Author Reply to Referee #1

18 November 2021

15 **The manuscript considers the effect of parameterization of wind forcing to wind generated waves in a shallow lake in China. The authors have developed a new method for estimating and modelling wind-driven current that is specifically suited for shallow lakes. A measurement campaign of wind and flow conditions was conducted to support the development of a wave-current coupled model.**

Fig. R1-1 Changes of wind drag coefficient with wind speed calculated by the equations proposed by Large and Pond (1981), Edson et al. (2013), Eqs. (R3) and (R4), $w_s \times$ Eq. (19)

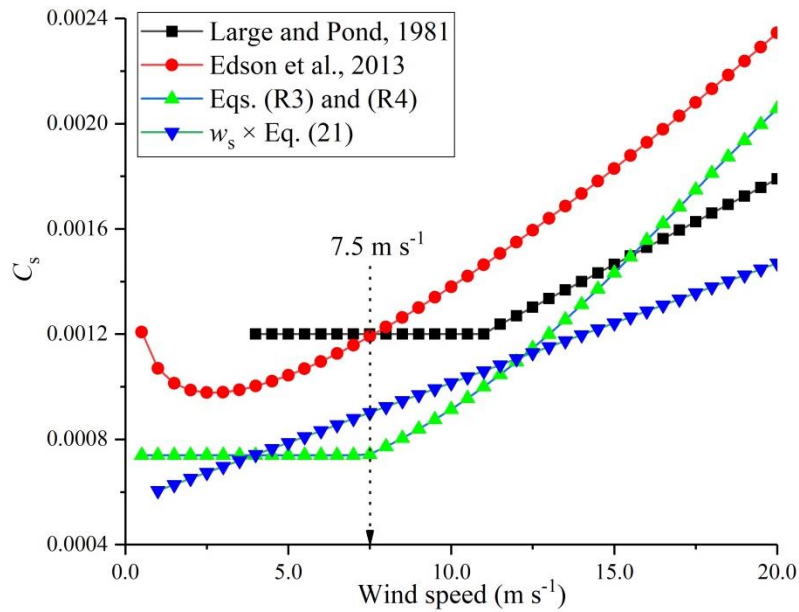
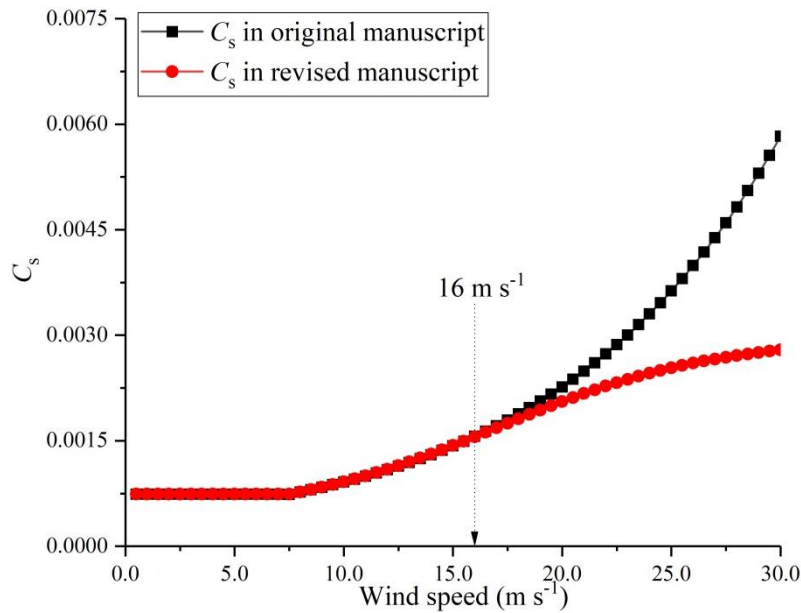
8 Chapter 4.1. You refer to this chapter (rows 124 and 181) for more information about the calibration of the model and deriving the wind drag coefficient. However, an explanation about the calibration process is missing. Please add a section describing clearly how the observation data was used to calibrate the model and how the wind drag coefficients were derived based on calibration and the observations.

The parameters in Eqs. (R1) and (R2) are determined as follows. Firstly, equaling to the wind speed related to aerodynamically rough water surface (Wu, 1980), the critical wind speed of 7.5 m s^{-1} is used to distinguish between light and high winds. Secondly, referring to the curve of Edson et al. (2013) (Fig. R1-1) and the upper limit of C_s (0.003) when wind speed is above 20 m s^{-1} (Geernaert et al., 1987), the expression of the logistic function in Eq. (R1) or (R2) is preliminarily determined under high winds. Finally, the process-based observation data of 2015 are used to determine the logistic expression and the parameters of a , and C_c by trial-error method.

It should be noted that the upper limit of C_s in the original manuscript has been toned down according to measured C_s reported by Geernaert et al. (1987). The reason of this modification is that: the maximum wind speed during the 2015 or 2018 field observation was less than 16 m s^{-1} , so that the change of C_s in the original manuscript had not been validated under wind speed $> 16 \text{ m s}^{-1}$. Actually, C_s in the revised manuscript is the same as those in original manuscript under wind speed $< 16 \text{ m s}^{-1}$ (Fig. R1-2). This implies that more field researches are required to determine the change of C_s under higher wind speed, despite this wind event is seldom happen for inland lakes.

180 Fig. R1-3 WCCM-simulated current speed of surface, middle, and bottom water layer during the 2015 field observation

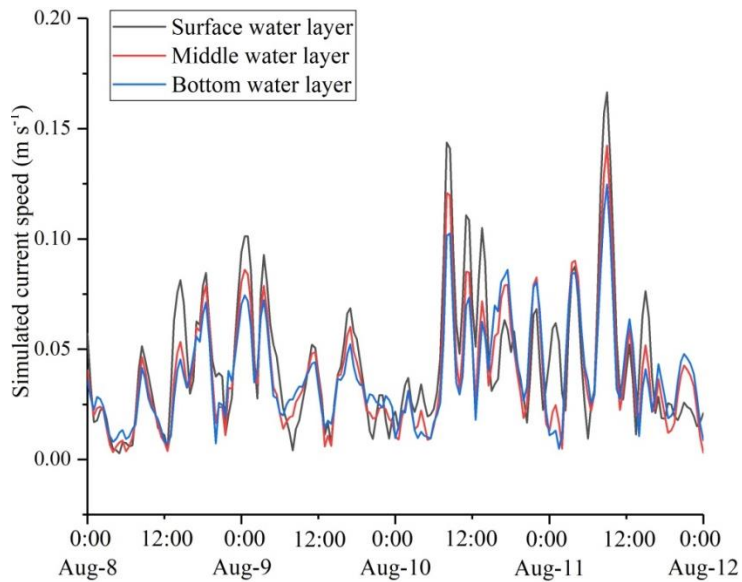
10 At row 241 you say that the measured flow speeds were lowest at the surface and highest at the bottom and it seems so also from Fig.7. Also in 2018 (row 262) the measured speed at bottom is highest. In simulations (Figs 6,7) the simulated surface speeds are generally higher than bottom speeds. Discuss why this is so.

The mean measured flow speed in the middle water layer is the highest during the 2015 field observation (Row 241), while it is the lowest during the 2018 field observation (Row 262). However,
170 the mean of simulated flow speed decrease with the increase of water depth.

In this study, the energy of lake hydrodynamics mainly transferred from winds because the influences of inflow and outflow were neglected. According to Ekman theory (Hutter et al., 2011), the magnitude of wind-driven currents decreases with the increase of the water depth in a water body. This is the cause of the decrease in the mean WCCM- or EFDC-simulated flow speed along water depth. The simulation
175 of wind-driven currents in Lake Okeechobe in America also indicated similar result (Jin et al., 2000). However, at some periods, the simulated flow speed in the middle or bottom water layer can exceed that in the surface water layer under the condition of the synergism of pressure gradient stress caused by the tilt of lake surface and low or reverse winds (Fig. R1-3).

Fig. R1-4 Flow measurement of ADP during the field observations

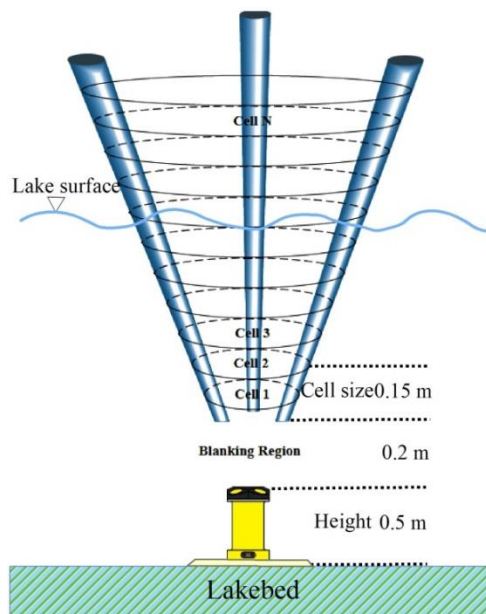
15 What were the blanking distances/dead areas of the ADP measurements? If they are
280 significant, please discuss if it affects the reported flow speeds and therefore the comparisons to
simulations. Do you compare the same height layers from model and ADP?

A surface plate equipped an upward looking acoustic Doppler profiler (ADP; SonTek Inc., USA; accuracy $\pm 1\%$ of measured velocity) was fixed on the lakebed (Fig. R1-4). The upward looking 3000
285 kHz ADP burst sampled current profiles every 30 min at 1 Hz. Each current profile is divided into 30 0.15-m-thick current layers (Cell 1, Cell 2,, Cell 30; Fig. R1-4). Moreover, the height of the blanking region and mounting height of ADP is 0.7 m, which means that there is no measurement within the height of 0.7 m above the lakebed. After the field observations, the effectiveness of measured
290 current velocity of each current layer (cell) is evaluated using the signal-to-noise ratio and water depth recorded by the ADP. Then the measured effective current velocity of surface, middle or bottom cell is used to validate the performance of hydrodynamic models at same or approximate height.
